# UNITED STATES PATENT AND TRADEMARK OFFICE

APPLICATION NO.	FILING DATE	FIRST NAMED INVENTOR	ATTORNEY DOCKET NO.	CONFIRMATION NO.
10/567,170	02/03/2006	Akimitsu Tsuda	1176/313	9622
46852	7590	12/11/2007	EXAMINER	
LIU & LIU 444 S. FLOWER STREET, SUITE 1750 LOS ANGELES, CA 90071			CARIASO, ALAN B	
			ART UNIT	PAPER NUMBER
			2885	
			MAIL DATE	DELIVERY MODE
			12/11/2007	PAPER

**Office Action Summary**

F i g . 4

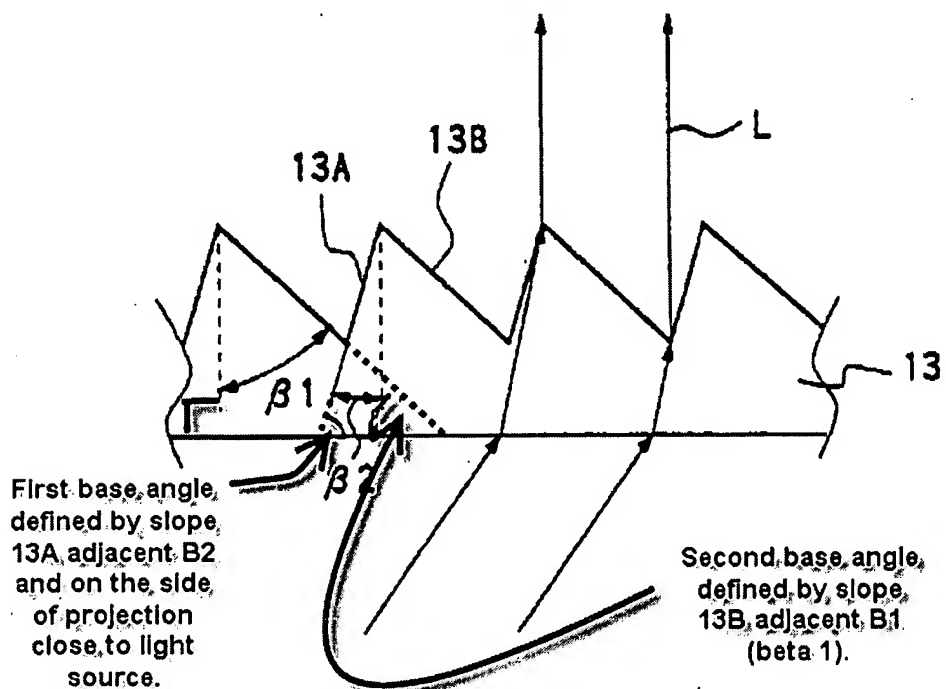
viewing angle improvement means (13) is asymmetric prism sheet (col.6, lines 40-41) having a plurality of projections (13A, 13B, fig.4 depicted below with added info.); wherein said projections of said asymmetric prism sheet (13) have a first base angle  $\alpha$  of  $75^\circ$  to  $90^\circ$  and a second base angle  $\sim$  of  $45^\circ$  to  $60^\circ$ . First base angle, shown below, and with the adjacent inclination angle  $\beta_2$  (of slope 13A), both form the acute angles of the smaller-area dotted right triangle. Similarly, the second base angle, shown below, and with the adjacent inclination angle  $\beta_1$  (of slope 13B), both form the acute angles of the larger-area dotted right triangle. OHKAWA discloses the inclination angles  $\beta_2$  and  $\beta_1$  defining slopes 13A and 13B, respectively, with respect to the normal erected on the general surface of the guide plate, as illustrated by the right angle dotted lines below.

OHKAWA discloses that inclination angle  $\beta_2 = 5.6$  degrees (col.6, line 52; col.9, line 29), which by simple geometry/trigonometry means the same as the first base angle being 90 minus 5.6, or 84.4 degrees. With the other inclination angle  $\beta_1 = 35$  degrees (col.6, line 52; col.9, line 29), it means that the second base angle is 90 minus 35, or 55 degrees.
